# UNITED STATES PATENT AND TRADEMARK OFFICE

APPLICATION NO.	FILING DATE	FIRST NAMED INVENTOR	ATTORNEY DOCKET NO.	CONFIRMATION NO.
10/693,607	10/27/2003	Brian E. Le Gette	GRAY032/01US	6475

**Office Action Summary**

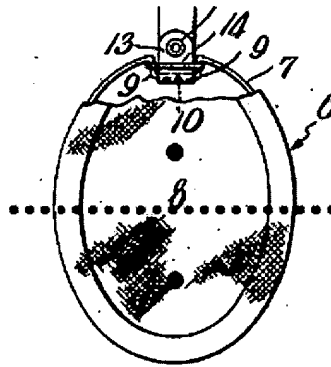
Claims 9, 16, and 17 rejected under 35 U.S.C. 103(a) as being unpatentable over Bean (US 2,149,383). Bean illustrates in Figs. 1-5 an ear warmer frame including a band portion 18 and an ear portion 7. The ear portion 7 is has an elliptical shape as shown below. Since the ear portion has an elliptical shape, it is inherent that the elliptical shape has two perpendicular axes as claimed. These two axes are shown as the dots above and below the dotted line. The line below divides the ear portion in half and shows the first portion (above the line) and a second portion (below the line) that are each curved around the first and second axes. Since there is no straight portion, to

break up the first and second portion, the examiner feels that the ear portion is made entirely of the first and second portion thus means the claimed limitations.

As to claim 11, Bean illustrates in Fig. 4 as shown above an ear portion 7 that tapers from the bottom of the first portion (at the dividing line) to the second portion (bottom half of the frame 7).
